7 December 2011

Proposed Modification (Mod 11) - Pool Deck Music to Major Project Approval No. 08-0098

DARLING POOL TERRACE n.t.s.

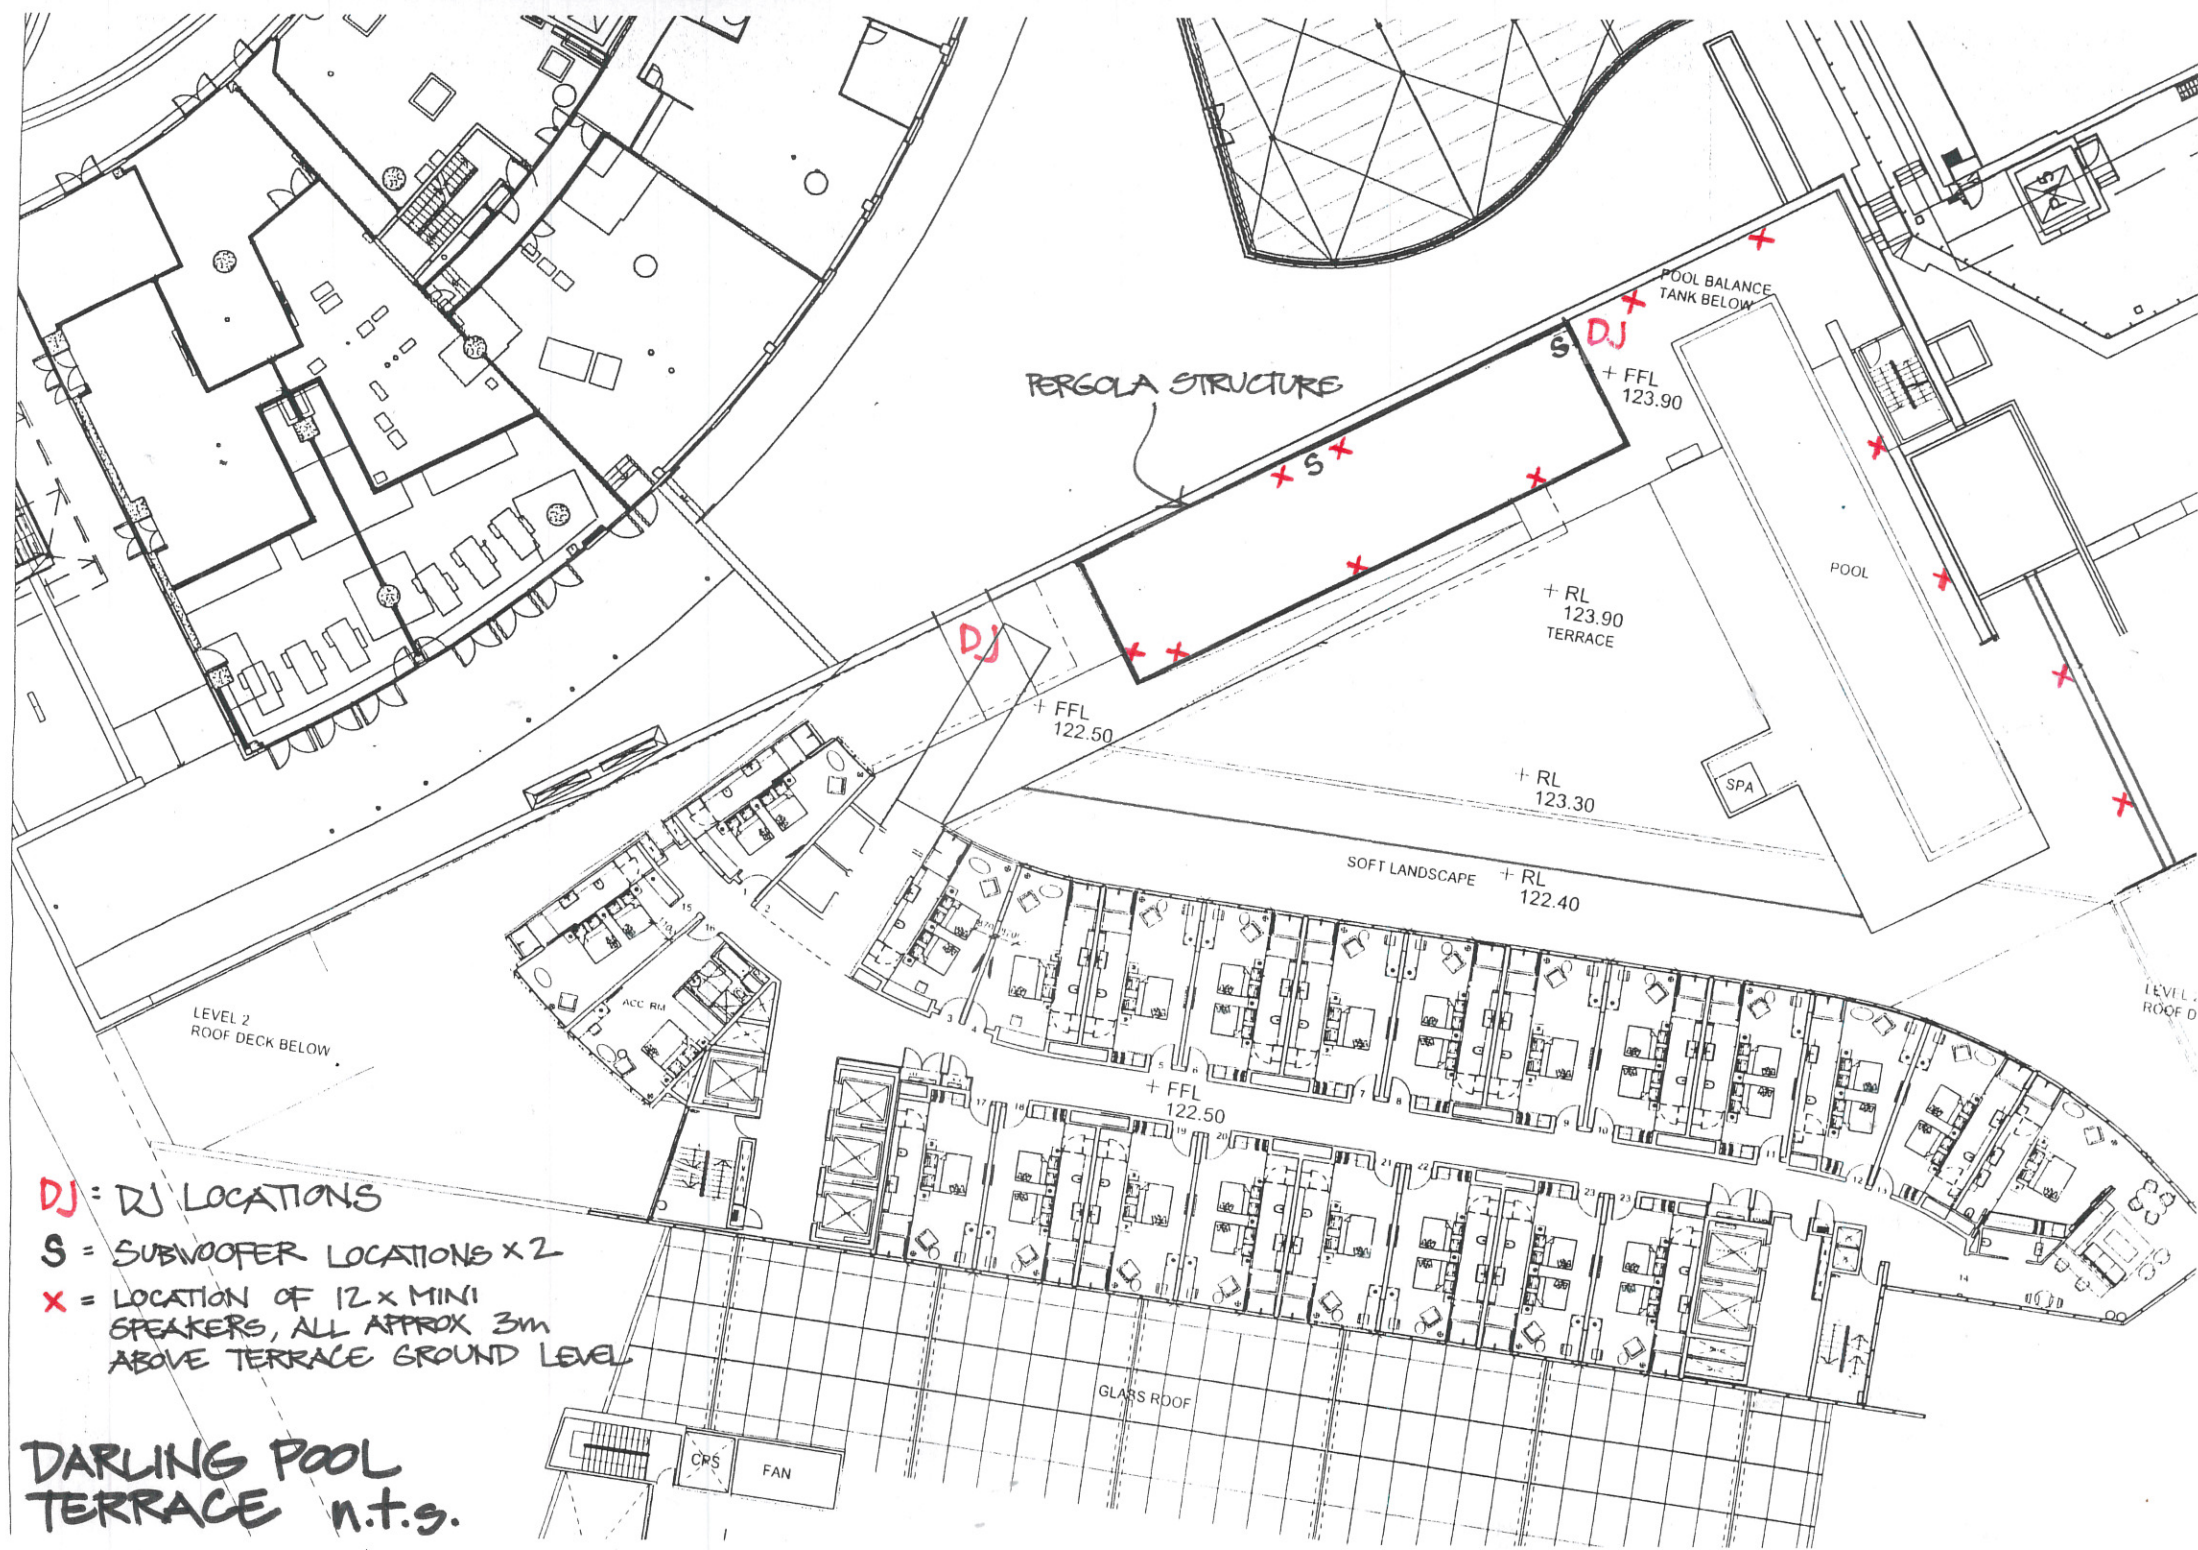
The applicant seeks to install and operate music speakers at the pool terrace on Level 3 of the Darling Hotel for playback of background music and DJ/live band/amplified music events. Details of the proposed sound system are:

- Twelve Meyer Sound Miniature speakers (MM-4XP) that are independently controlled and mounted at a height of approximately 3m from floor level around the pool terrace; and two subwoofers under a pergola structure to be used for playback of background music.
- An Extended Level Integrated Active System (ELIAS) being a standard set up consisting of two speakers for DJ/live band/amplified music events. The twelve MM-EXP and subwoofer system will only be used for announcements of no longer than 1minute in any 15 minute period during these types of performances.

Attachment A provides a plan of the speaker locations.

The speakers that are permitted to be installed to the Level 3 Outdoor Pool Deck area of the hotel development are limited to twelve Meyer Sound Miniature speakers (MM-4XP) and two subwoofers. The location of the speakers is illustrated in plan titled “Darling Pool Terrace”.

*Speakers must not be installed and music must not be played in any of the outdoor areas associated with the premises including the public domain and outdoor terraces/decks/gaming areas, **excluding the Level 3 Outdoor Pool Deck area of the hotel development.** Speakers located within the premises must not be placed so as to direct the playing music towards the outdoor areas associated with the premises.*
